ADDENDUM NO. 2

**PROJECT NAME: BARBARA DRIVE DRAINAGE PROJECT (McCULLOUGH
AVE TO SKIPPER DR)**

DATE: 01/17/2017

TCI PROJECT NO.: 23-01398

SUBMITTAL	PROJECT NUMBER	DATE
100%	E0384400	1/17/2017
DRWN BY:	DSGN BY:	CHKD BY:
EV	KS	MB
		SHEET NO.
		14

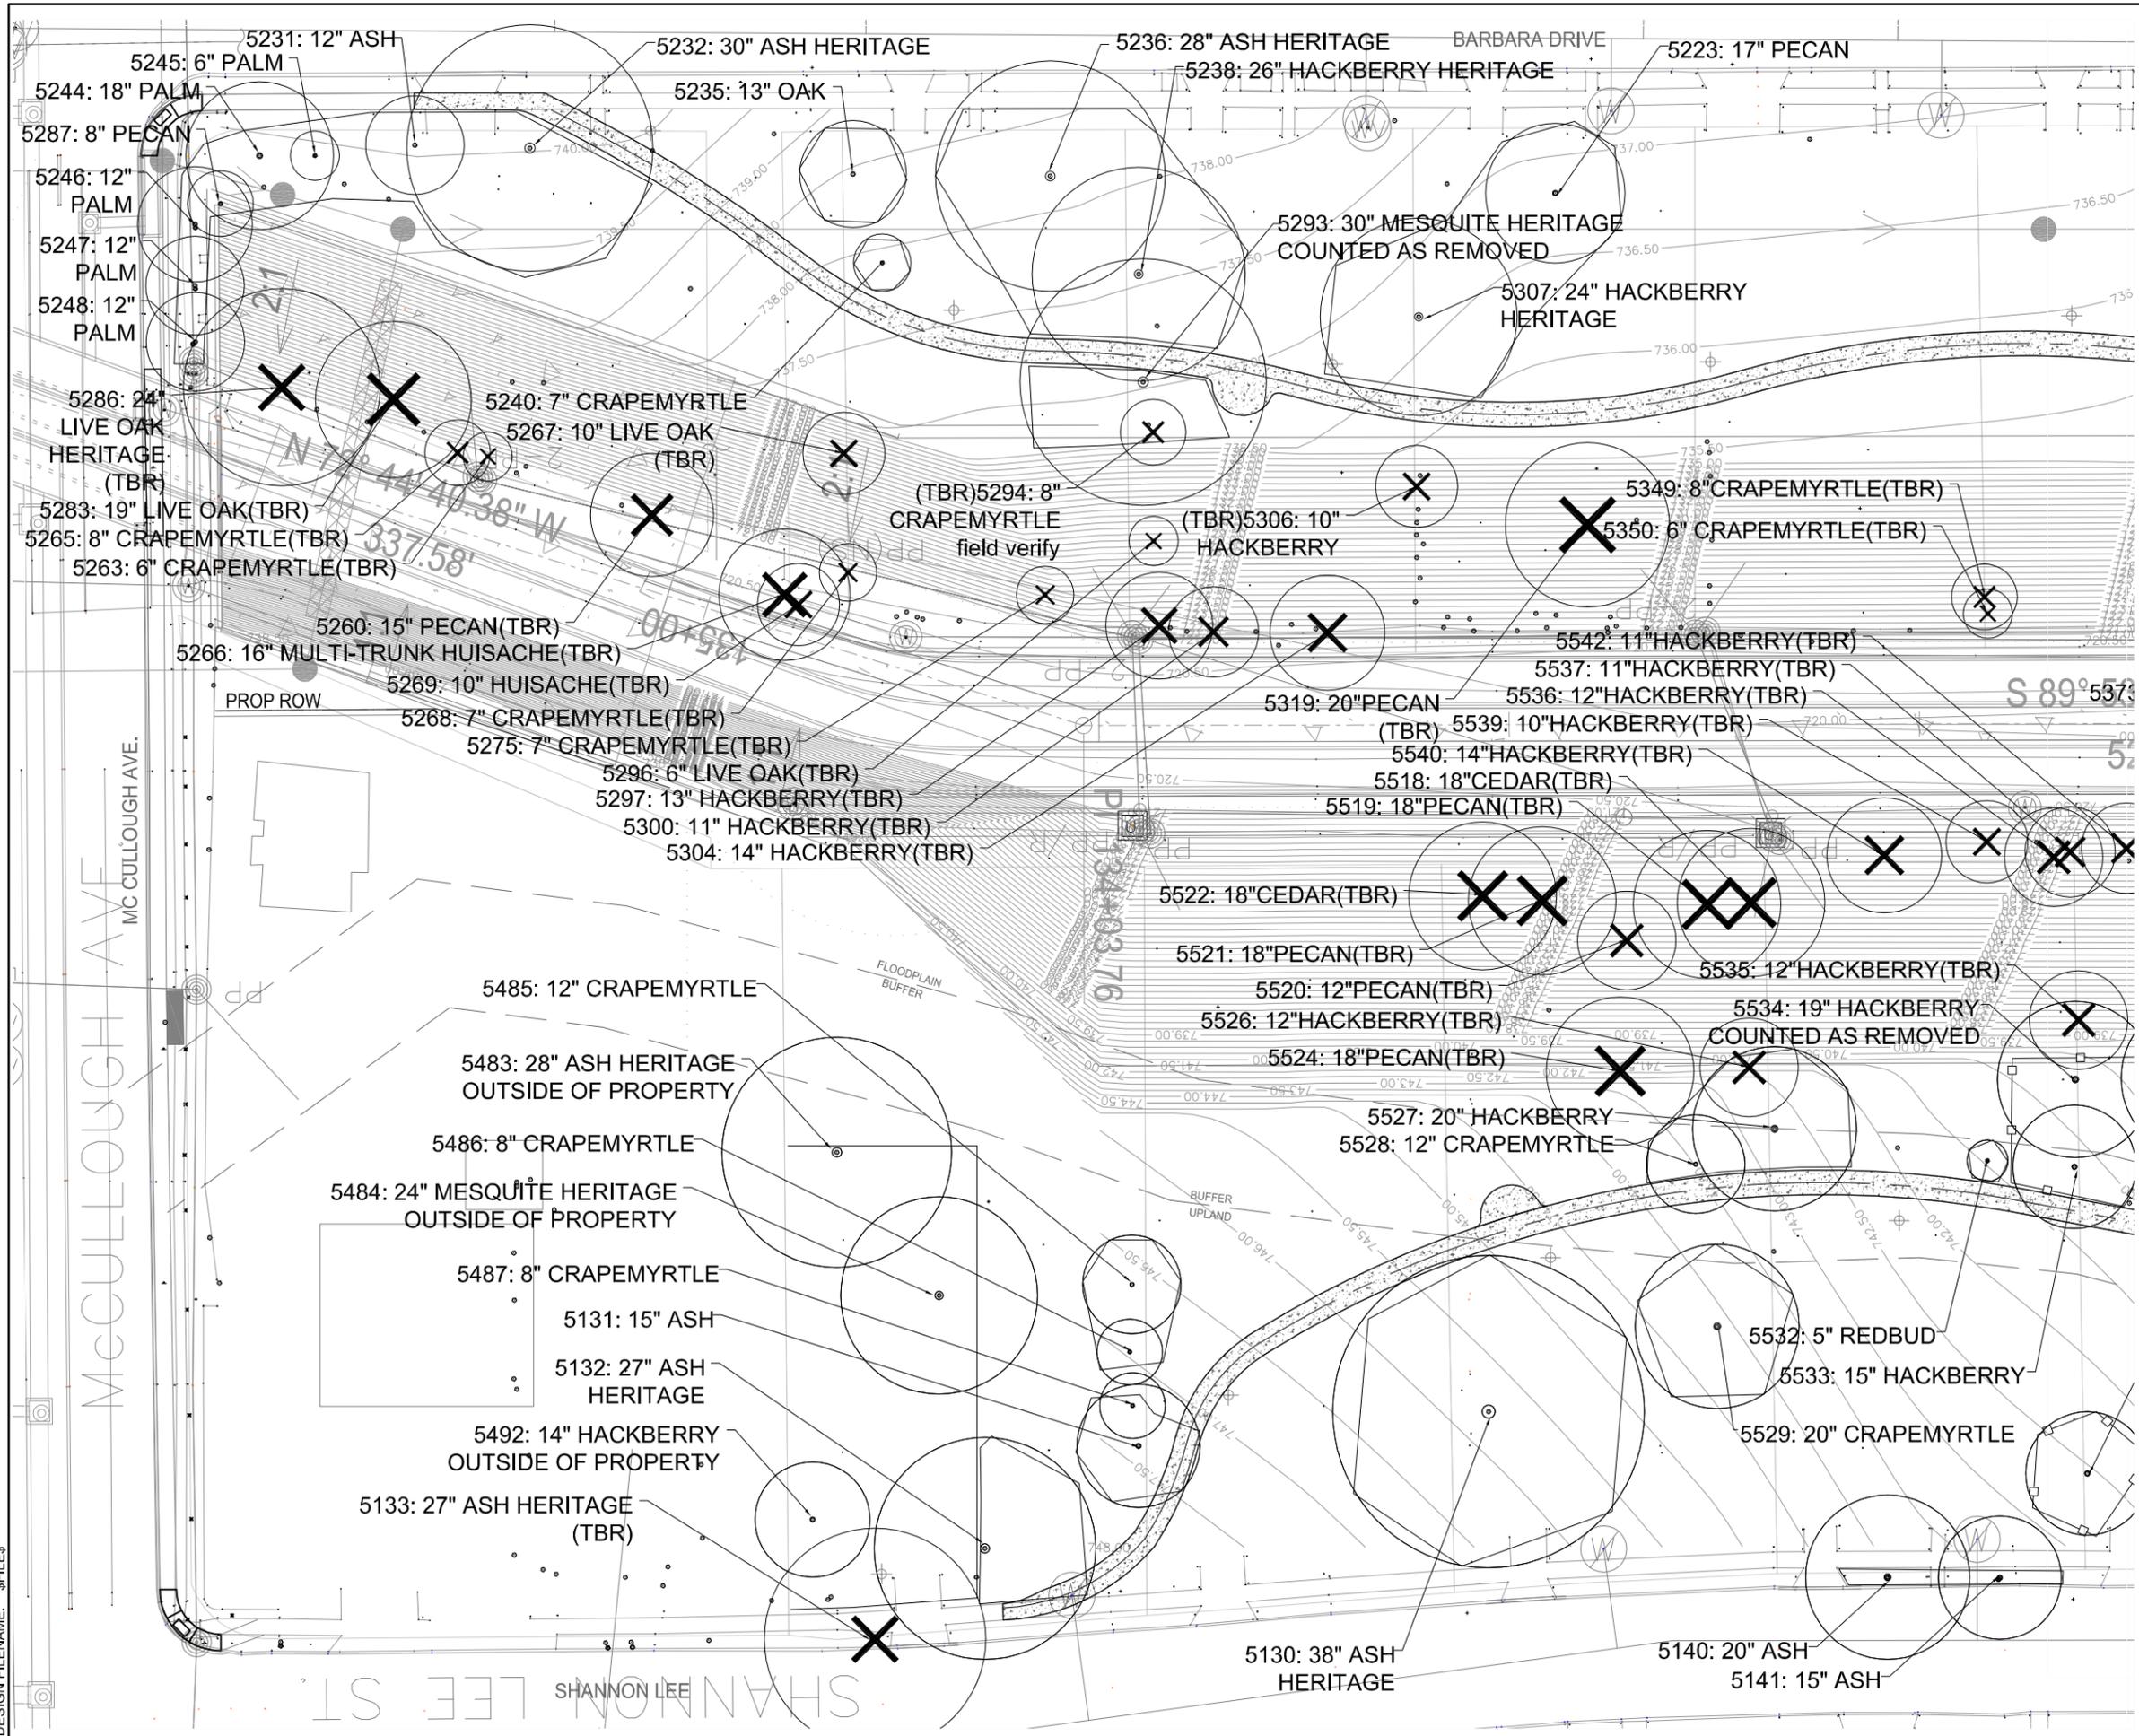
- 5. Updated E&Q Sheet and Summary sheets as follows:
 - a. Added Section for ADD ALT #3 which includes Bid Item 9999 “Channel Excavation, Transport/Disposal of Material to Landfill Facility” per CY; quantity estimated at 112,637 CY

- b. Added Bid Item 205.5 “Hot Mix Asphaltic Pavement, Type B (2.5” Comp. Depth) (PG 70-22)” per SY; quantity estimated at 293 SY.
 - c. Reduced quantity for Bid Item 205.5 “Hot Mix Asphaltic Pavement, Type B (2.5” Comp. Depth) (PG 64-22)” to 679 SY.

- d. Added Bid Item 508.1 “Relocating Wire Fence” per LF; quantity estimated at 150 LF
 - e. Added Bid Item 6004.1 “Utility Pole Bracing” per Each; quantity estimated at 1 EA

- f. Added Bid Item 450-6042 “Rail (TY PR1)” per LF; quantity estimated at 113 LF
 - g. Reduced quantity for Bid Item 450-6051 “Rail (TY E)” to 525 LF
 - h. Revised Bid Item Number to be 540.10 for Curb Inlet Gravel Filters

- i. Revised Bid Item Number to be 403.10 for Inlet (Grate) (MOD)
 - j. Revised Bid Item 620.1 Electrical Conductors #6 CU AWG quantity from 3,200 LF to 3,140 LF

- k. Revised Bid Item 620.1 Electrical Conductors #4 CU AWG quantity from 2,800 LF to 2,630 LF
 - l. Revised Bid Item 620.1 Electrical Conductors #8 CU AWG to Electrical Conductors #8 CU GND

- m. Revised Bid Item 620.1 Electrical Conductors #2 CU AWG to Electrical Conductors #2 CU
- 6. Updated “Enlarged Tree Preservation Plan” (sheet 77) to revise tree classification for Tree # 5266 to a Heritage Tree.
